City of Surrey
PLANNING & DEVELOPMENT REPORT

File: 7908-0170-00

Planning Report Date: July 23, 2012

- **OCP Text Amendment**
- **Rezoning** from RF to CD (based on RM-70)
- **Development Permit**

SHEET TITLE:
 MAIN FLOOR PLAN

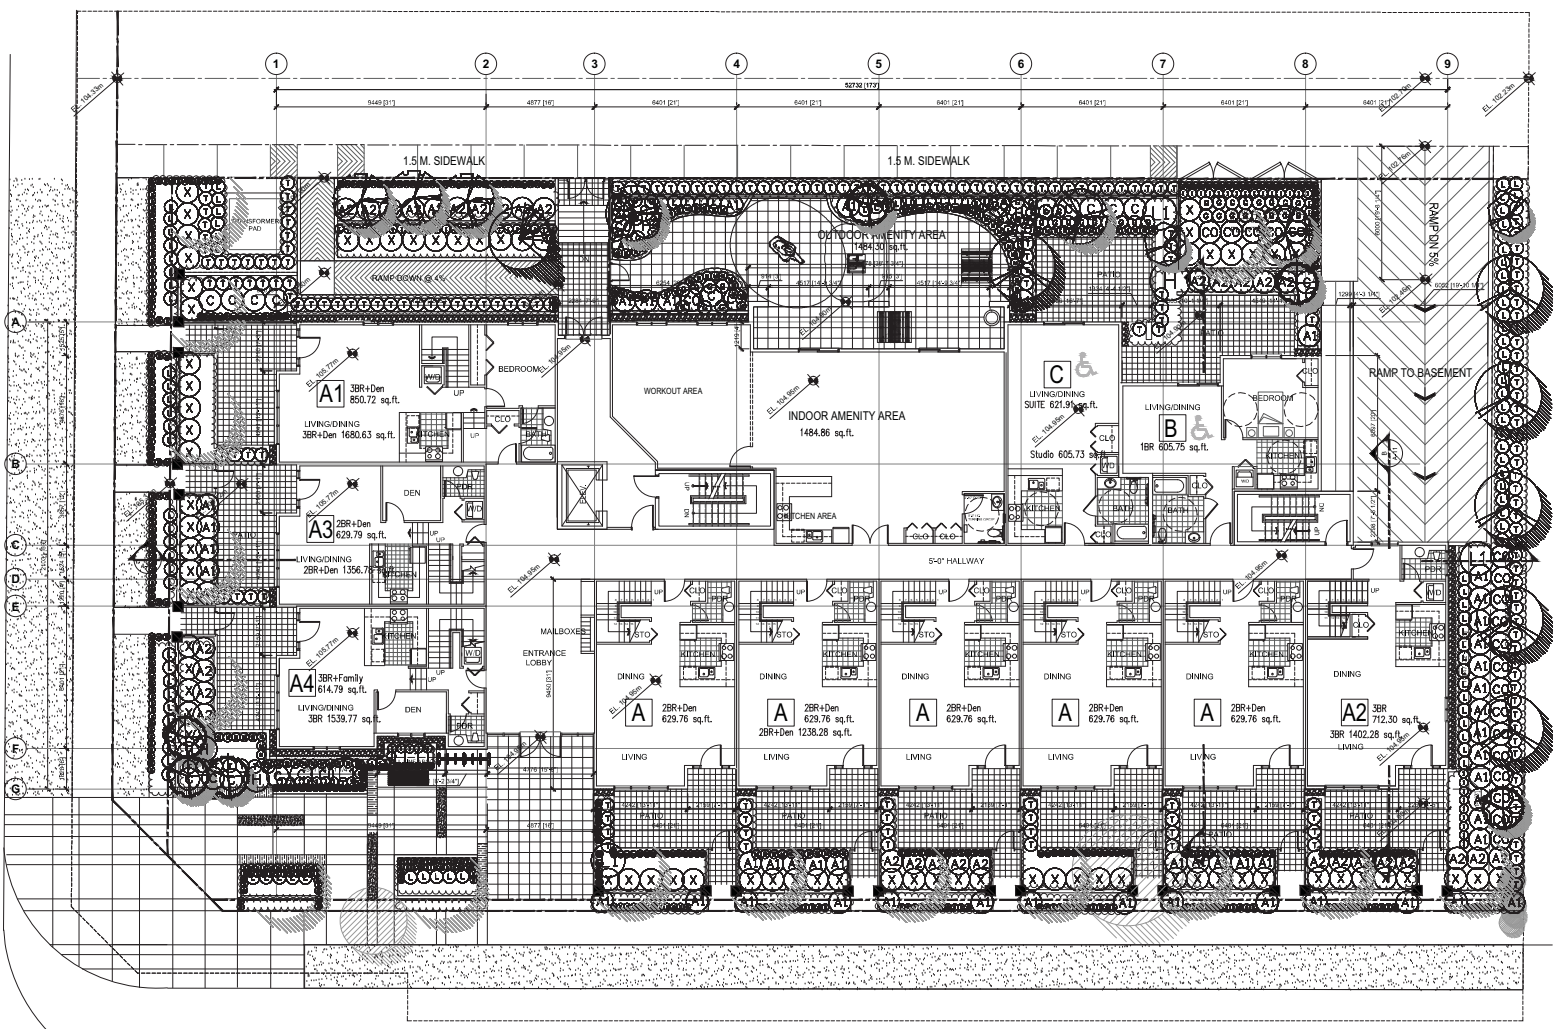
- The townhouses are nicely articulated but need a way finding to suggest 'this is the front of the building'. Take the 6 townhouses and move the width of the lobby south. Provide a clearer demonstration of the conceptual order of the building. Appears as all variations without having first established the theme.

- Rethinking space planning, many units appear difficult to use. Scale of living places is radically out of tune with balance of bedrooms on a large unit, doors to townhouse patio need relocation at a minimum.

(The townhouse units have been moved southward to provide more articulated units.)

(Unit plans have been revised accordingly and a spatial balance for bedrooms and living areas has been achieved. The main entrance door to the townhouse units has been moved to the front.)

ELEVATIONS

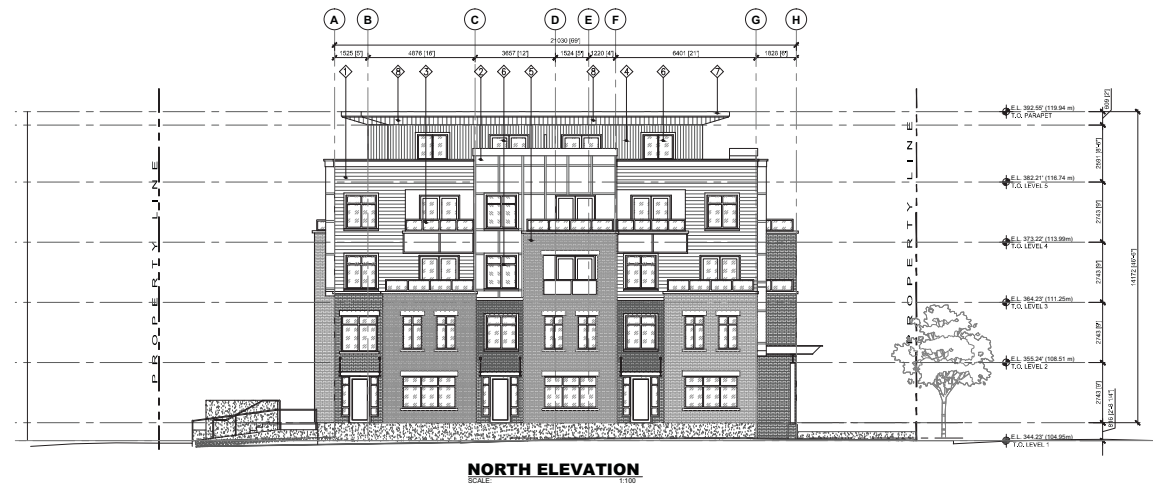
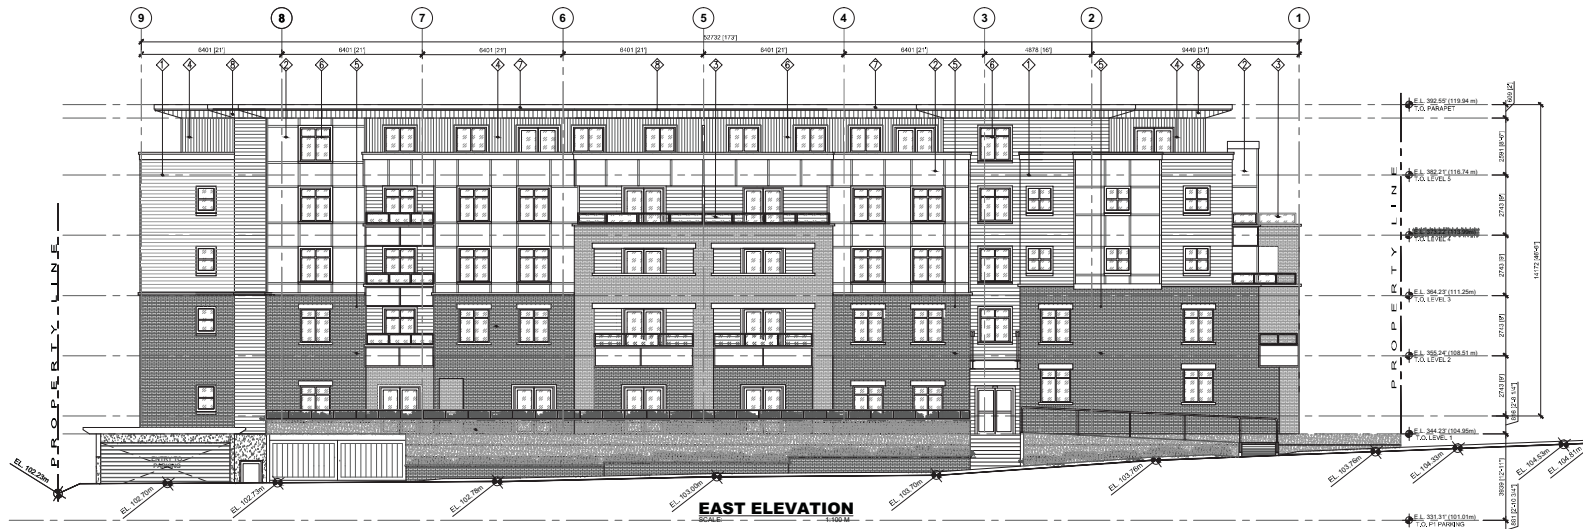
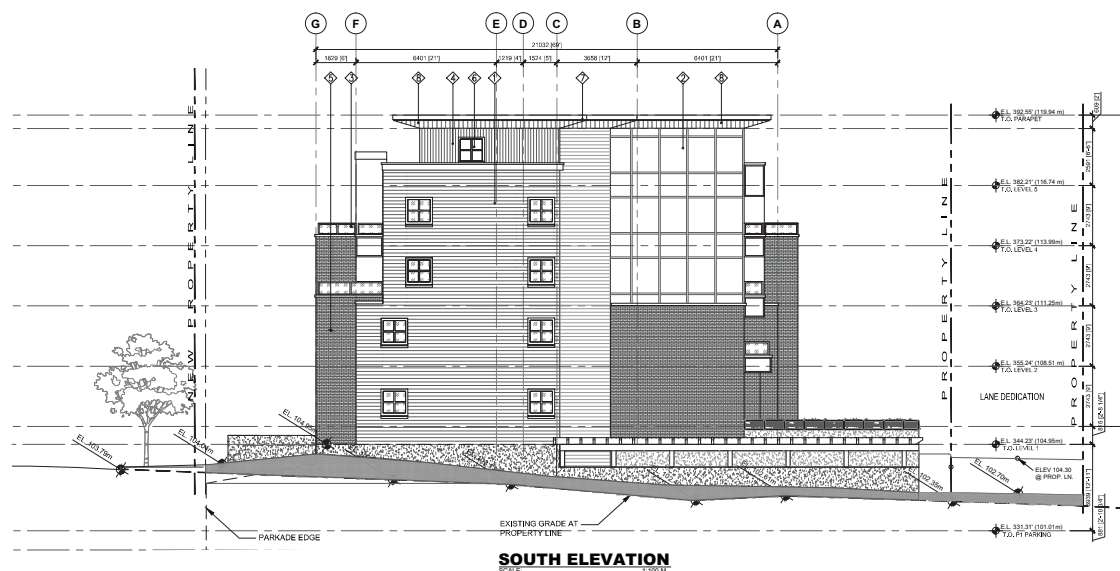
- Need to revisit scale and detail of windows and modulation along south elevation and south-east portion of east elevation, break up blank wall feel.

(The window detail has been updated and the location has been altered to break up the blank wall effect on the south-east and east elevations.)

DRAWING TITLE:
LANDSCAPE PLAN

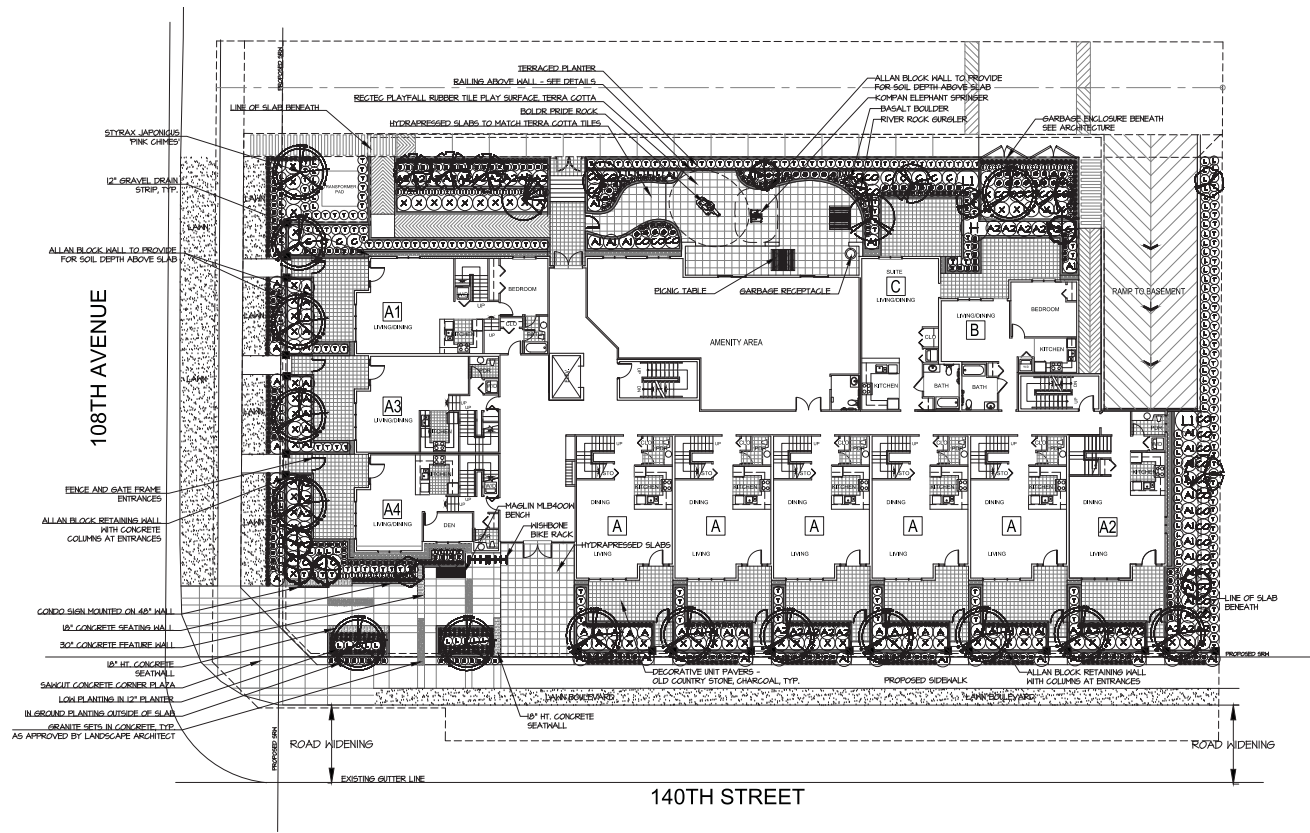
- Like the plant material, like marking entrances with slightly different landscaping expressions at the thresholds.
(No action required).
- Would like to see better integration of the corner sidewalk nodes and landscaping / signage rather than a lawn strip. Work with Planning on how to work around the property line.
(Corner sidewalk nodes and landscaping have been revised. Refer to latest landscape drawings.)
